March 28, 1980

The following additional information is provided in support of our renewal application for byproduct materials license no. 13-00418-02 (control no. 02846), as requested during Mr. Pettijohn's visit to our facility on February 28, 1980.

Ventilation Pattern in Nuclear Medicine
Area as of MARCH 21, 1980

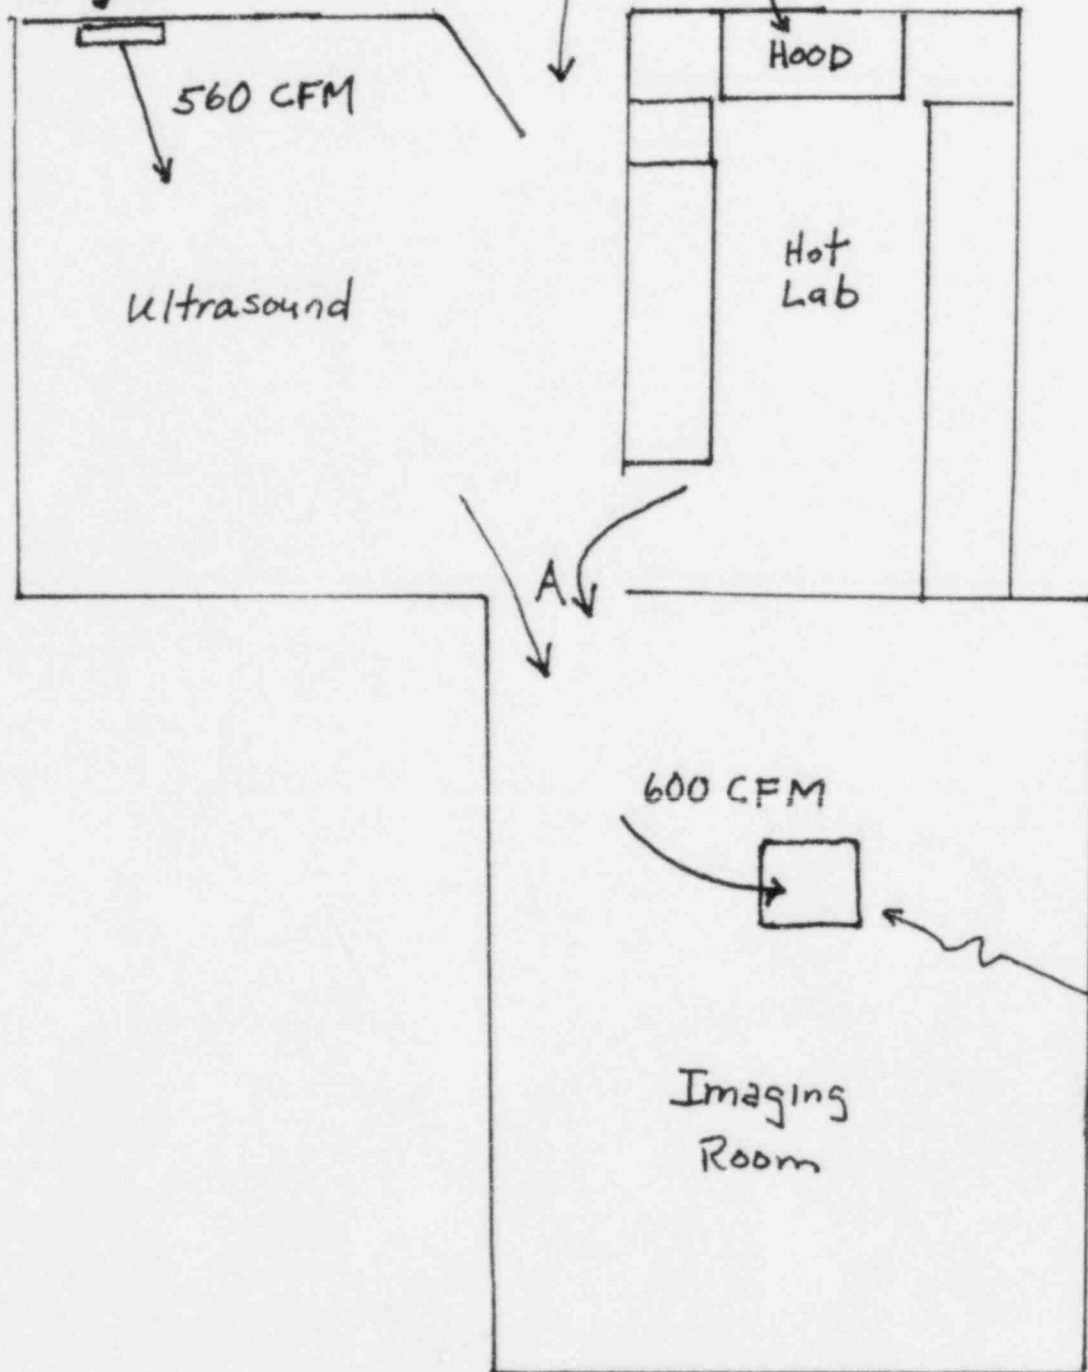
At the present time, the hood in the hot lab is not functioning. However, air leaving the hot lab through the doorway will be exhausted through the vent in the nuclear imaging room due to the large negative pressure at doorway A (see diagram). The 600 CFM exhaust vent in the imaging room exhausts directly to the outside with no recirculation and there are no intake vents in the imaging room. Thus, makeup air is provided only through doorway A, creating a substantial negative pressure in the vicinity of this doorway. This is accentuated by the fact that there are no exhaust vents in the ultrasound area, and that the air intake vent in the ultrasound room is located on the wall and directs the air across the ultrasound area toward doorway A.

Since the Xenon-133 is obtained in unit dose vials, leakage of Xenon-133 is most likely to occur during the actual patient procedure which takes place in the imaging room. The unit dose vials are stored in the hood in the hot laboratory behind lead bricks. While this room is not under negative pressure at this time, the potential for release of Xenon in this room is small, and if present, any Xenon will be cleared through the imaging room exhaust vent after it leaves the hot lab. As soon as the hood exhaust is again functional, the hot lab itself will be under negative pressure.
